ADDENDUM #1

Bay Street Temporary Bridge Installation
Tender Number: RFT-2026-02

BAY STREET BRIDGE REHABILITATION

PROPOSED ABUTMENT DETAILS AND GENERAL NOTES

HD	GH	MK	FP
DRAWN	DESIGNED	CHECKED	APPROVED
AS NOTED		2026/09/29	
SCALE		DATE	
260649	2	S3	
PROJECT No.	REVISION	DRAWING

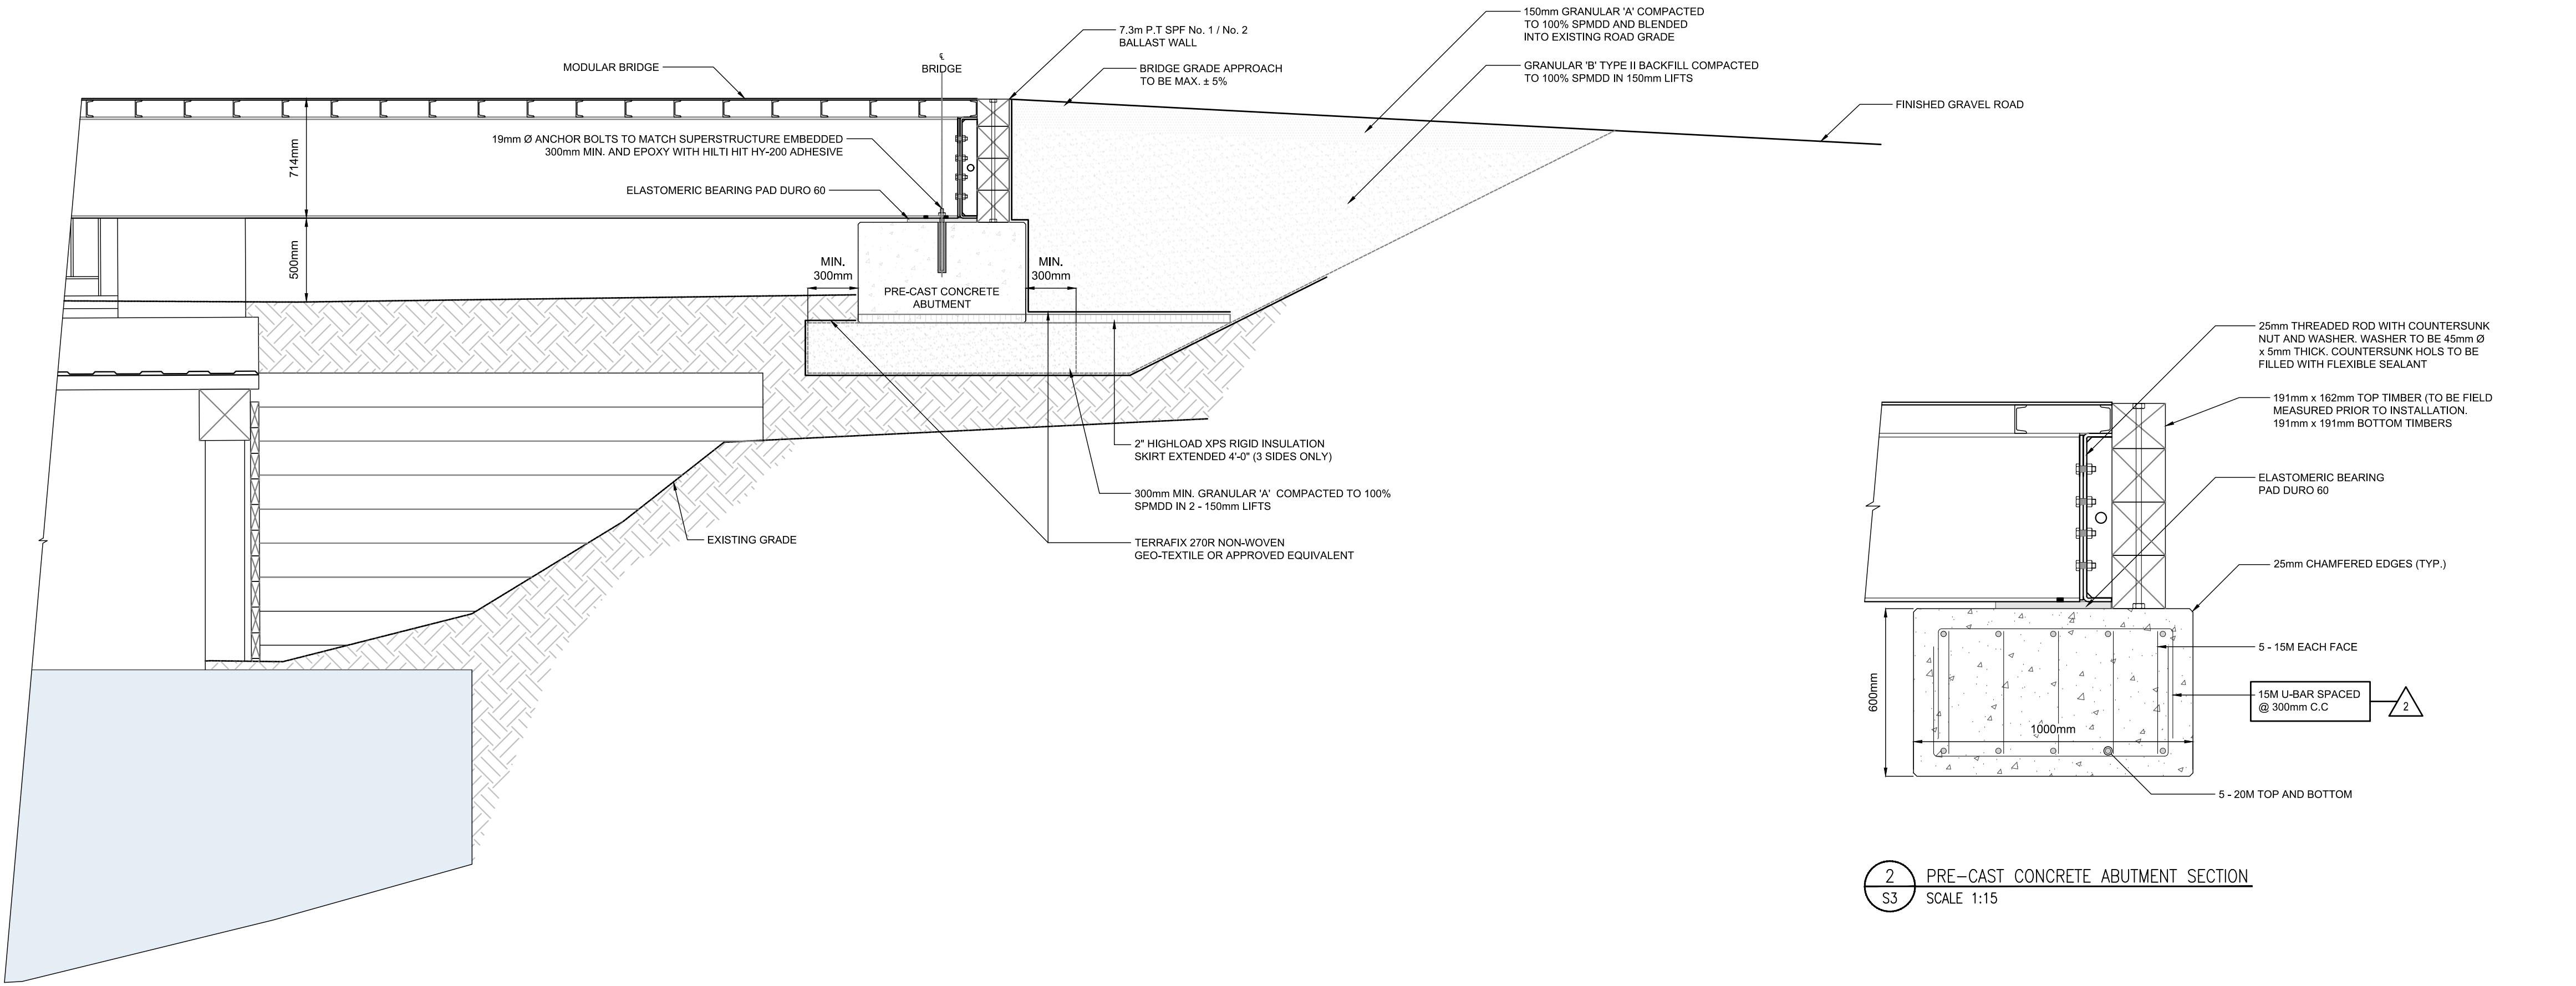
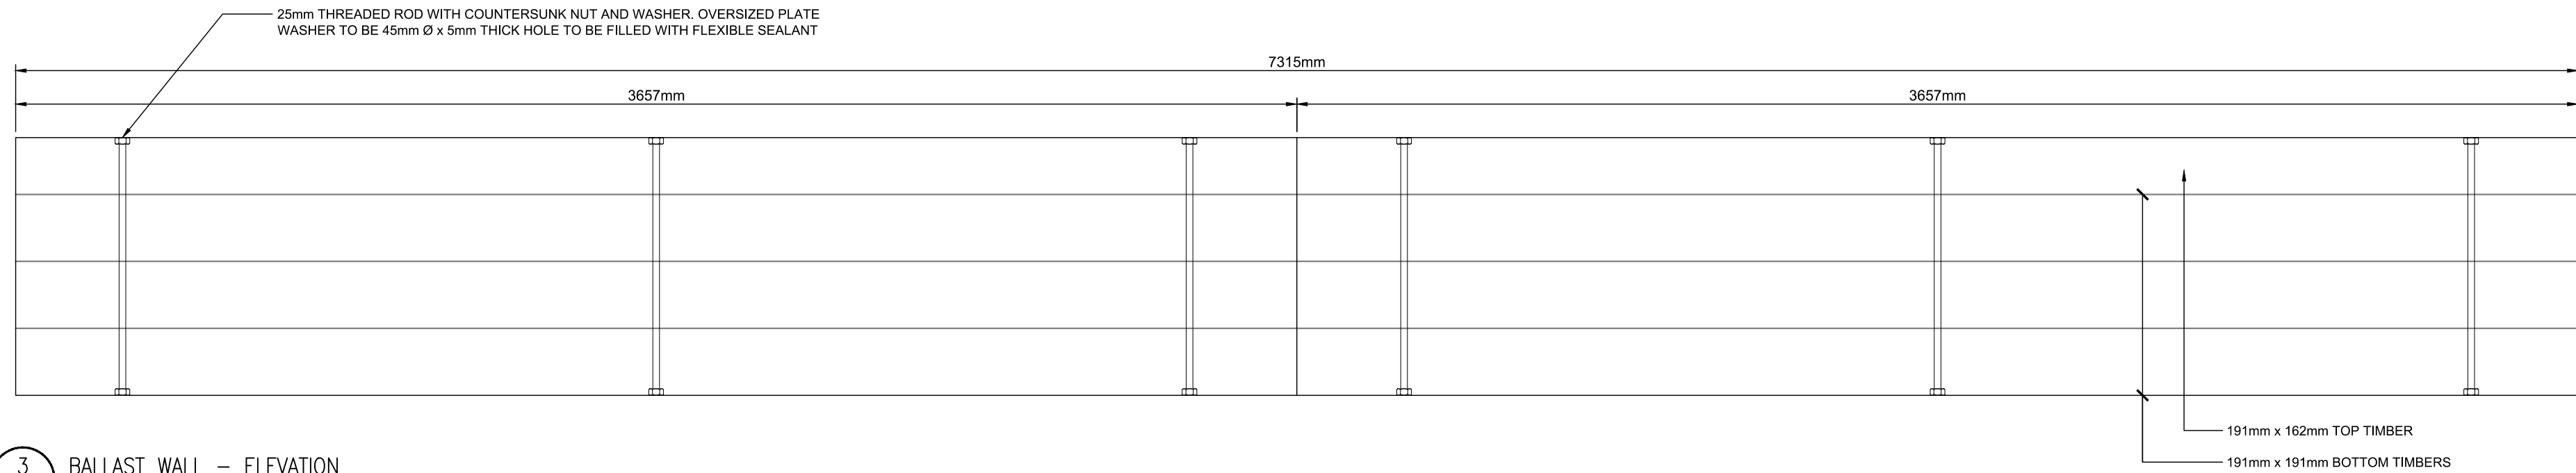
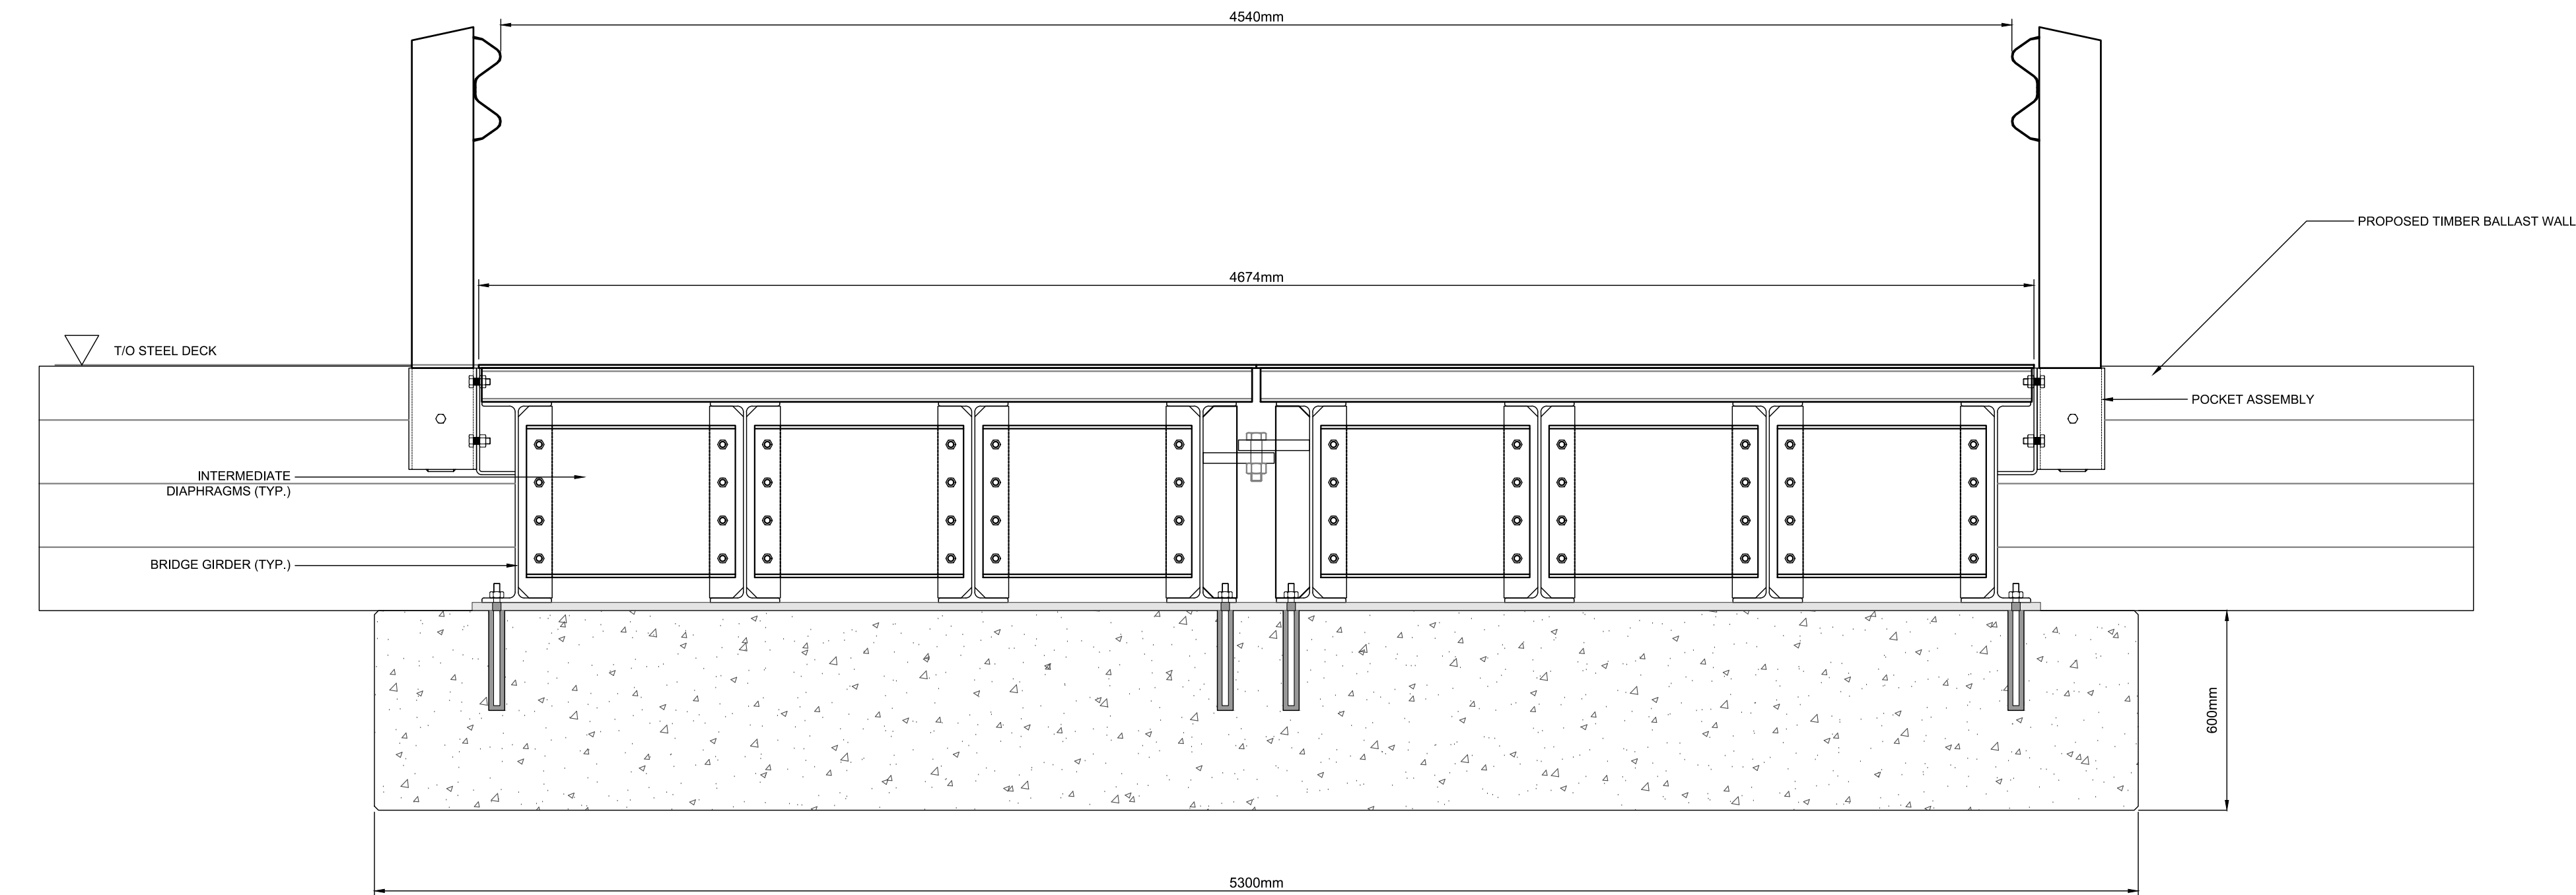
Question 7: Can you confirm the bar size and spacing for the “U bars” on the precast concrete abutment?

Question 8: The tender document refers to precast concrete strip and pad footings; however, I cannot locate these on the drawings provided.

Answer 7: See revised drawing set S3.

Answer 8: The precast concrete strip and pad footings are referring to Detail 2 on Drawing S3 of the Contract Drawings.
